# C2M spec consistency and tolerancing

Johan J. Mohr and Piers Dawe  
Mellanox Technologies

- Topic: C2M module output (200GAUI-4 and 400GAUI-8 )
- Five requirements to the eye: Table 120E-3

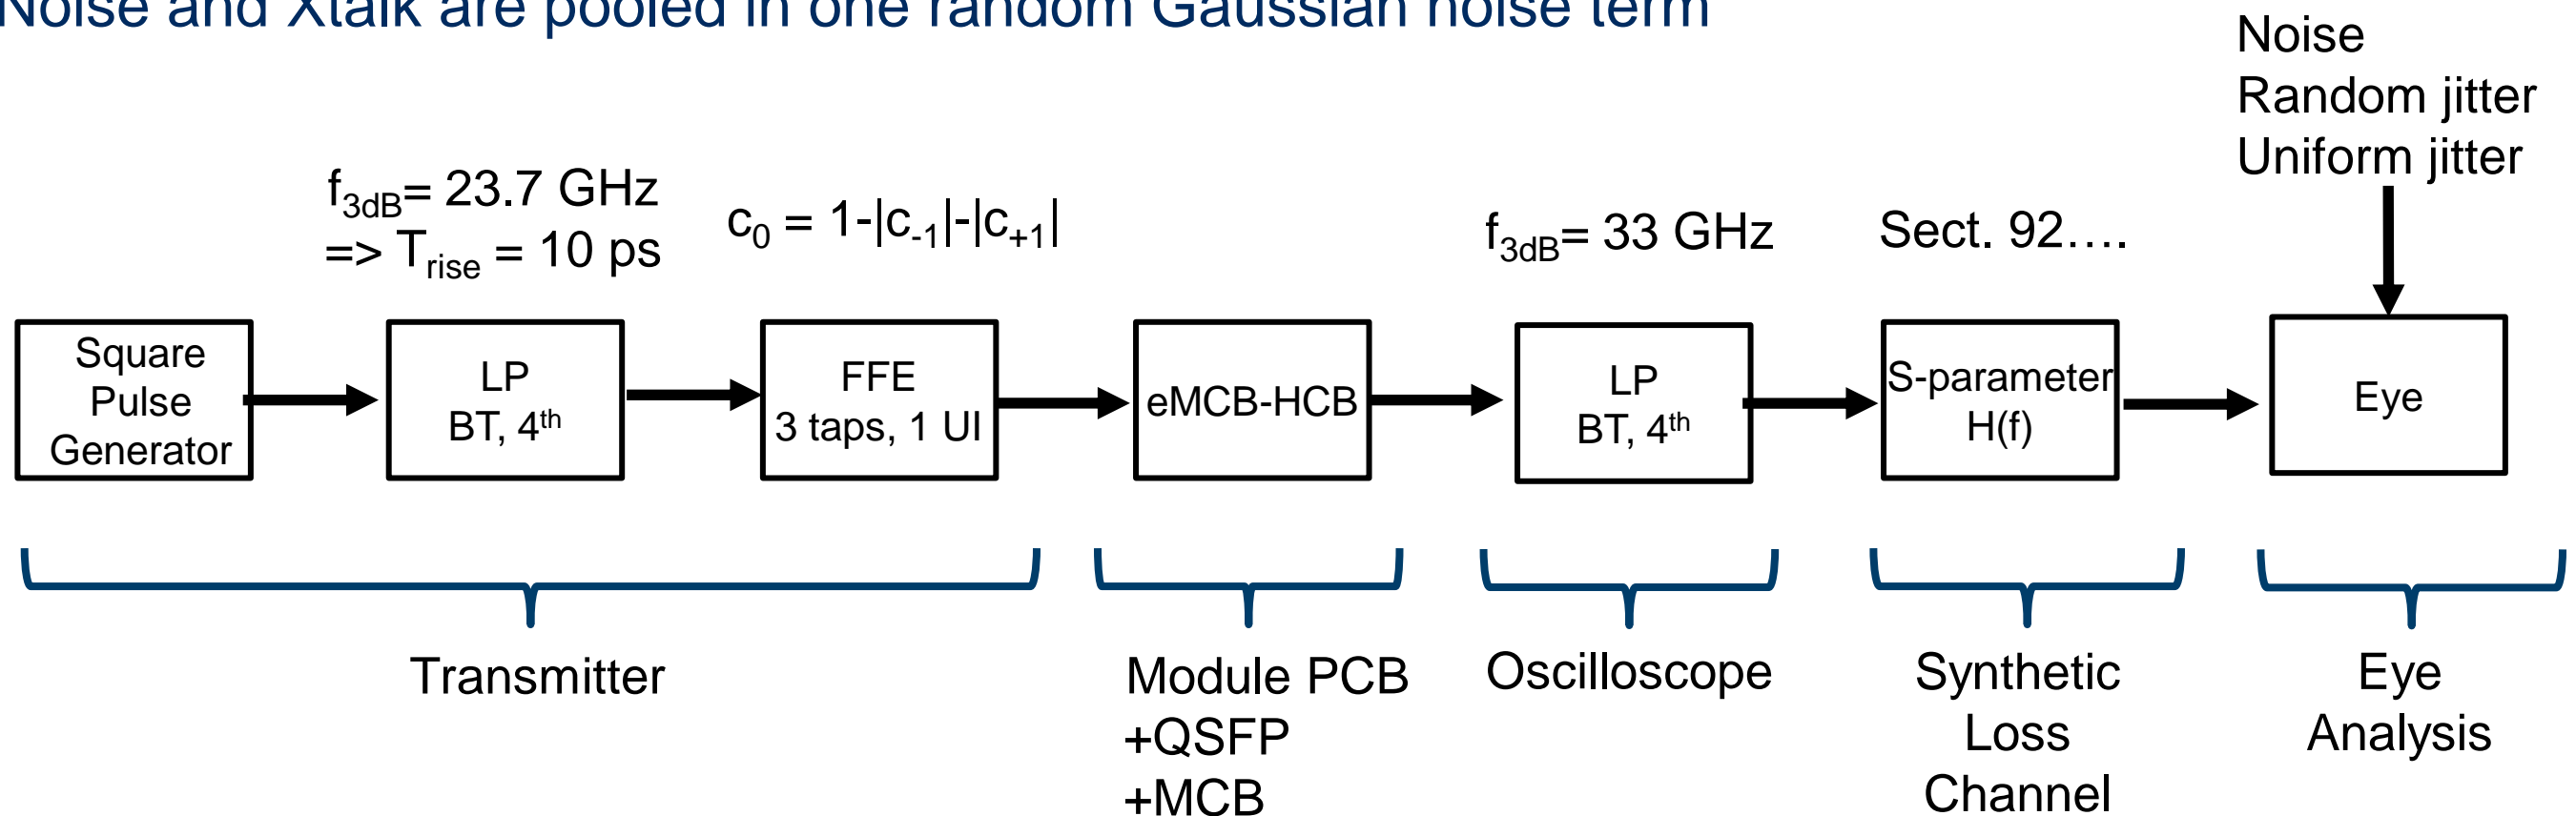
- Question 1: *Can all five be fulfilled at the same time?*
- Answer 1: *Probably; but the five optima do not appear at the same module Tx-emphasis setting*
- Question 2: *Does the auxiliary far-end pre-cursor ratio requirement restrict module tuning?*
- Answer 2: *Current pre-cursor ratio requirements seems to force module Tx-emphasis to be set away from the most reliable (optimal) with respect to eye width and height*

- In one example channel:
  - High jitter case: pre-cursor ratio and far-end eye optima (width and height) differ
  - High noise case: better alignment between optima

- Change Proposal
  - **Increase (or offset) precursor ratio limits to e.g. [-2.5%; 5%]**
  - **Relax the near end eye height limit**
    - From 70 mV to 45 mV
  - **Wording change**
    - See last slide
